Invitation to Bid 16068 Fabricated Steel Module Structure  
Addendum 1

Addendum 1 is issued to answer the following questions:

STATE OF ALASKA, AIDEA/AEA  
RURAL POWER SYSTEM UPGRADE  
KIPNUK LIGHT PLANT  
KIPNUK, ALASKA

2 PARTIAL GENERATOR ROOM BACK WALL INTERIOR ELEVATION  
 3/8"=1'-0"

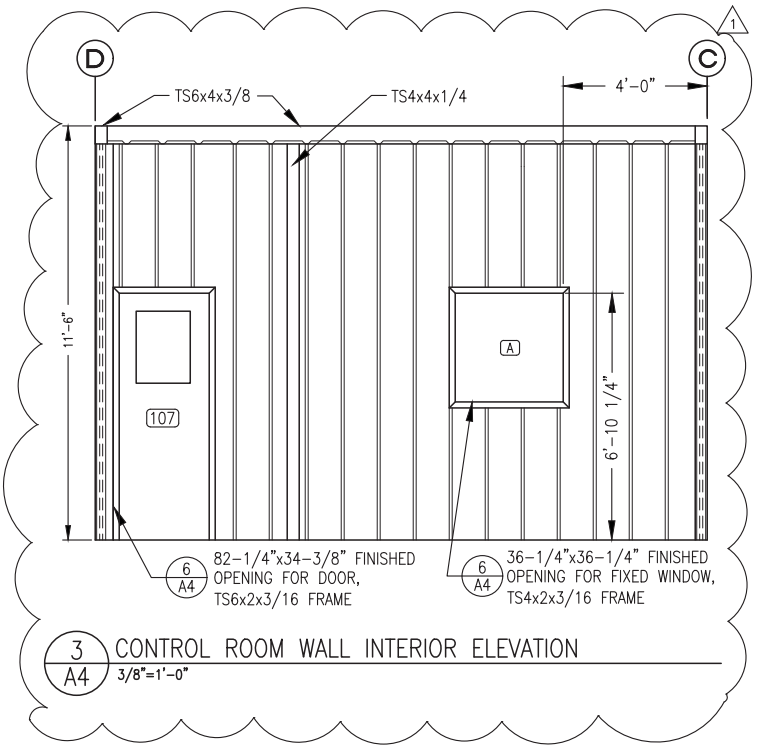
2. Also sheet A4, det. 2, calls out top perimeter as TS 6 x 4 x 3/8 and on sheet MP1, det. 1, calls out as TS 6 x 4 x 1/4?

Answer: The reference on sheet MP1 is incorrect. RB-1 is a TS 6 x 4 x 3/8 as indicated on sheets A4 and S4.

3 CONTROL ROOM WALL INTERIOR ELEVATION  
 3/8"=1'-0"

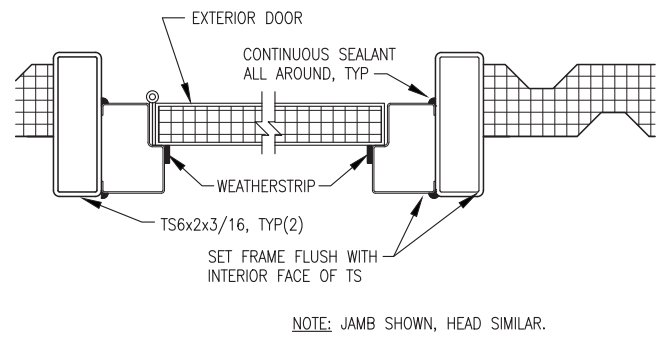
11. On Sheet A4, details 1 & 2 denote the interior elevations as being 11'6". Detail 3 shows the control room interior as being 10' in height. The measurement given does seem to indicate that the control room measurement is to the bottom of the 6"x4" header. Even so, assuming that the header accounts for 6", there is a 1' disparity. Is this an accurate measurement?

Answer: The control room height is 11'-6" to the bottom of the 6x4 header. See sheet A4 Revision 1 for a corrected detail.

6 INTERIOR DOOR AND WINDOW JAMB/HEAD  
 3"=1'-0"

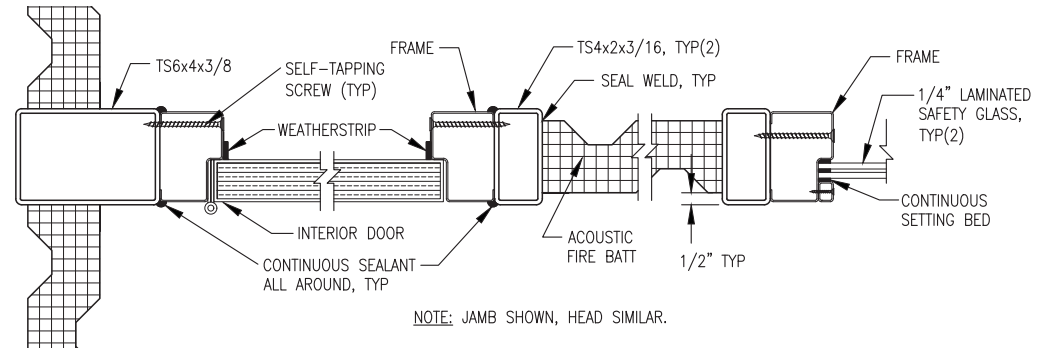
1. Sheet A4, det. 6 (lower right hand corner of page) calls out the exterior wall column as TS 6 x 4 x 3/8, and on Sheet A2 calls it out as TS 6 x 4 x 1/4 in det. 1, which is correct?

3. In reference to door jambs, sheet A4, det. 6, calls out as TS 4 x 2 x 3/16 and det. 3, same sheet A4 calls out TS 6 x 2 x 3/16?

Answer: The structural column at Grid 3 is a TS 6 x 4 x 3/8 as indicated on sheet S4 while the non-structural column at Grid 2 may be a TS 6 x 4 x 1/4 as indicated on sheet A2.

Answer: The door jambs on the interior walls (Grids 2 and 3) are TS 4 x 2 x 3/16 while the door jambs on the exterior wall (Grid A) are TS 6 x 2 x 3/16.

DRAWING TITLE:  
MODULE CONNECTION  
DETAILS

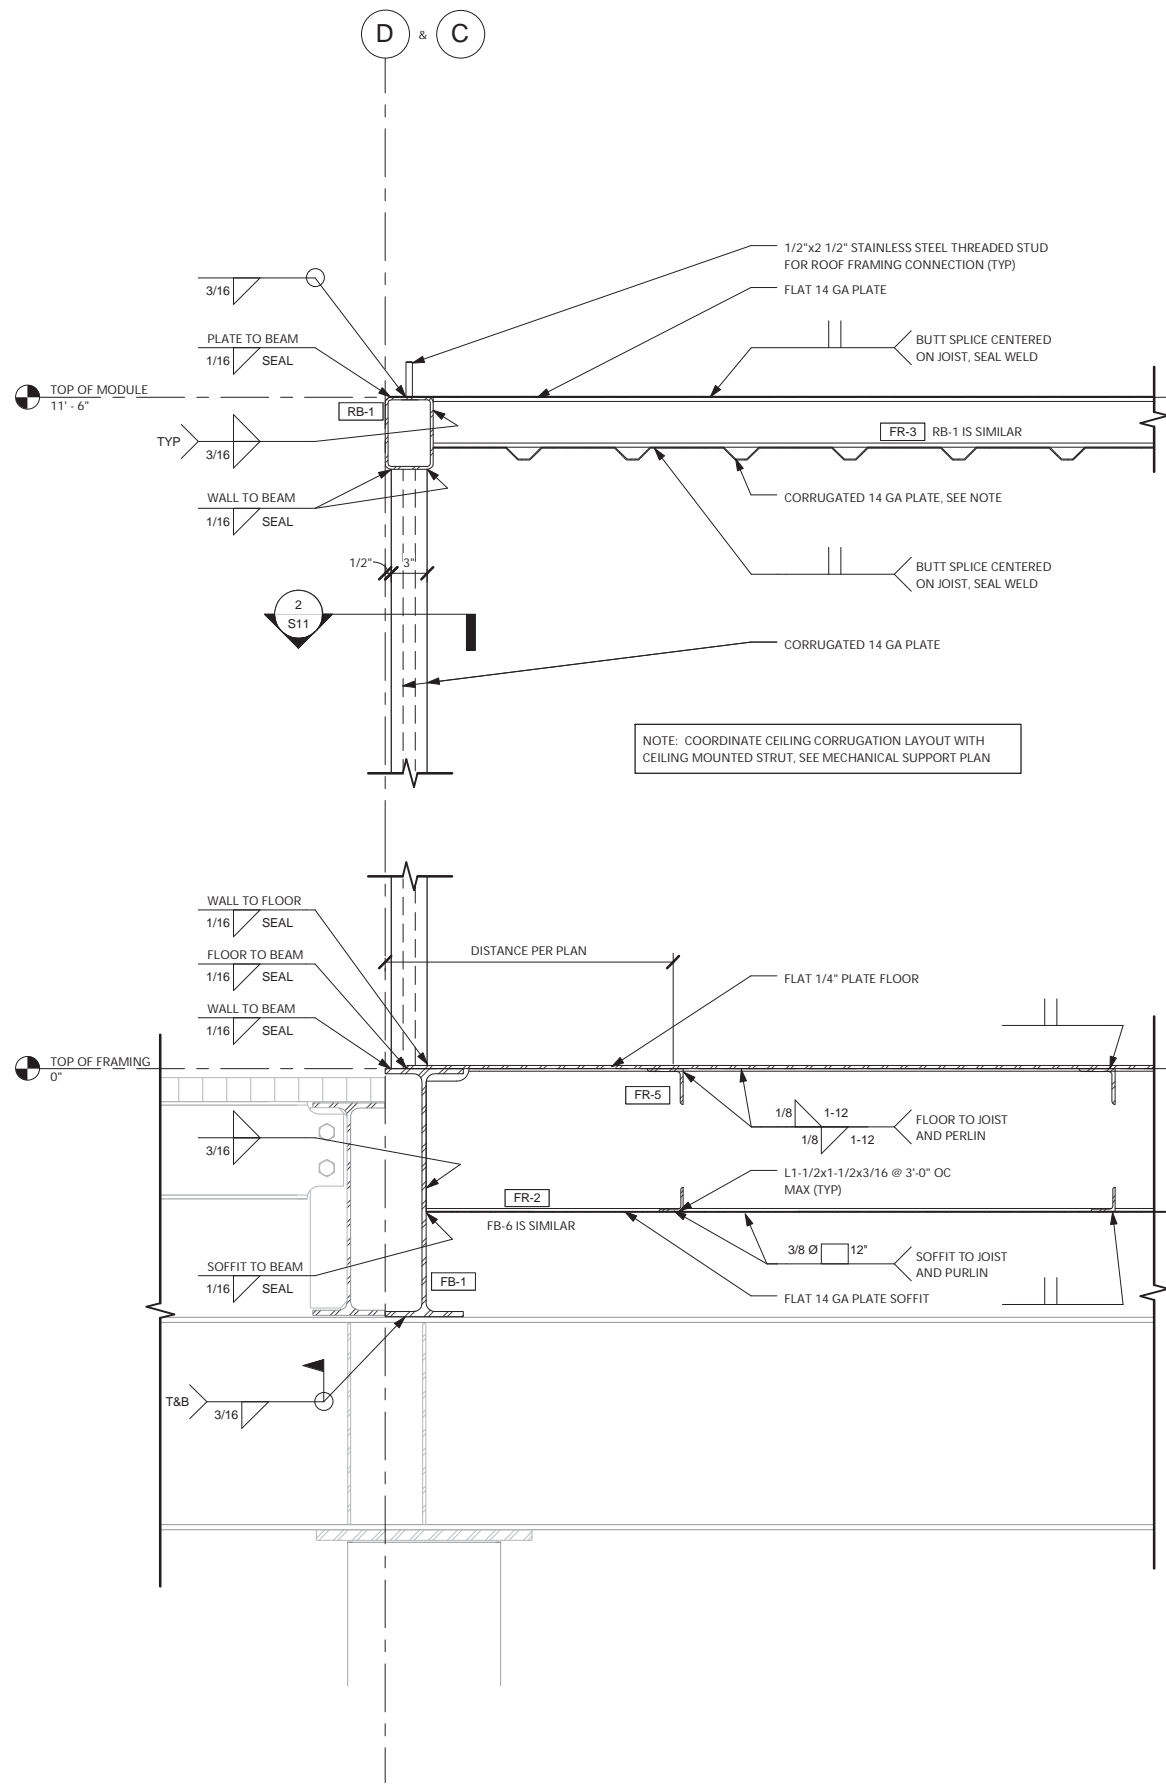
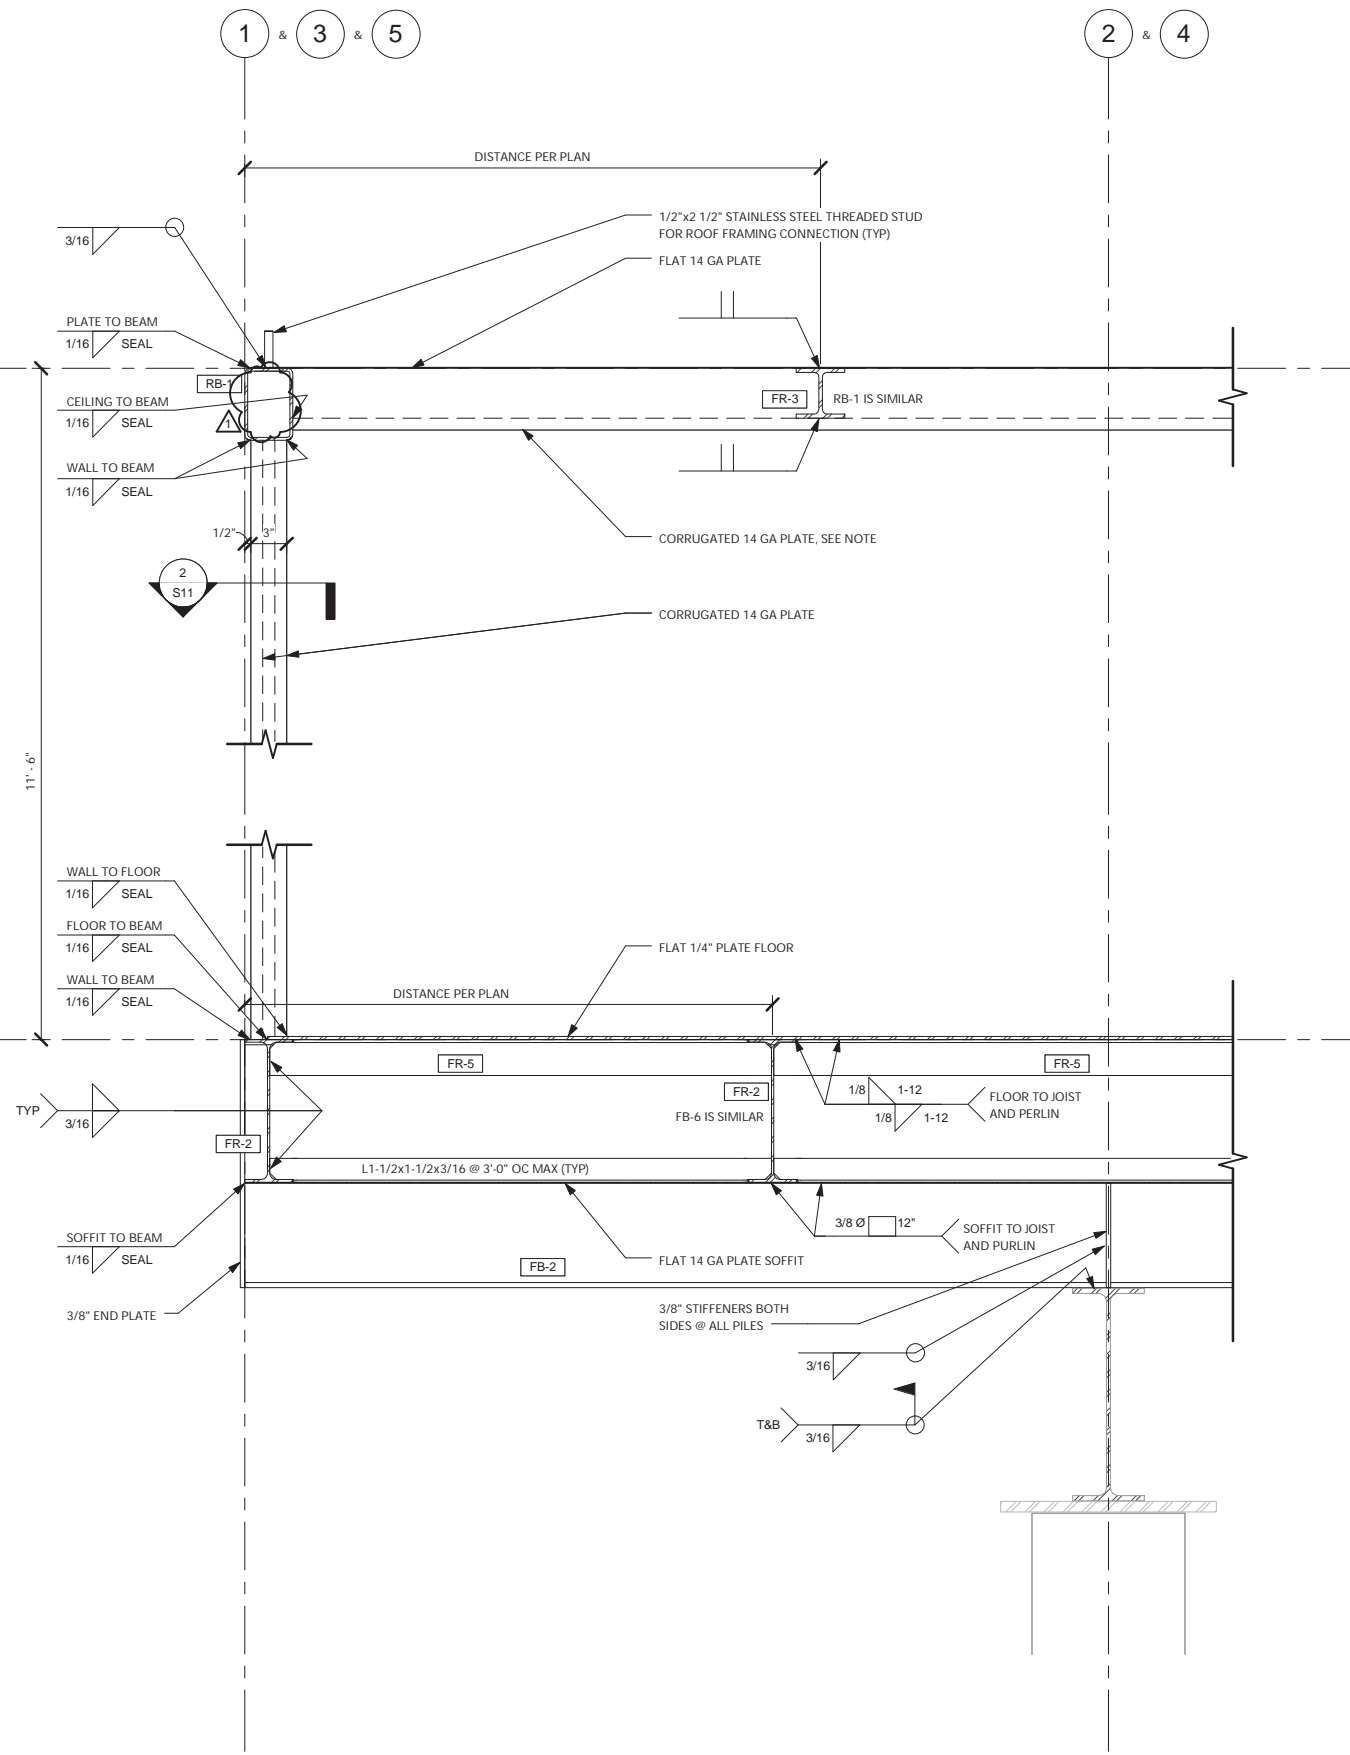
8. Sheet 5, grids 1,3, and 5 show some sort of stud into the tube?

Answer: There is no stud in the tube. See sheet S5 Revision 1 for a corrected detail.

1 LIFTING EYE & COLUMN CONNECTION  
S11 1 1/2" = 1'-0"

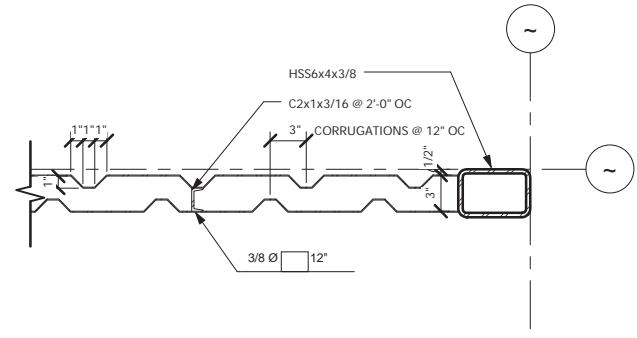
9. It appears the 4-each lifting eyes at the common end walls will conflict with each other as drawn. Can they be rotated 90 degrees? This would position them knifed into the tube column the 6" way, thus leaving a 1/4" of the 6 1/2" pad eye exposed for welding. The way depicted at present, knifed in the 4" way leaves a 1 1/4" exposed each side of the tube column thus they would butt up against each other leaving a 2 1/2" gap between the modules.

Answer: The detail has been corrected to show the 6-1/2" pad eye running parallel to Grid lines 1, 3, and 5 (the 6" dimension of the tube). See sheet S11 Revision 1 for a corrected detail.
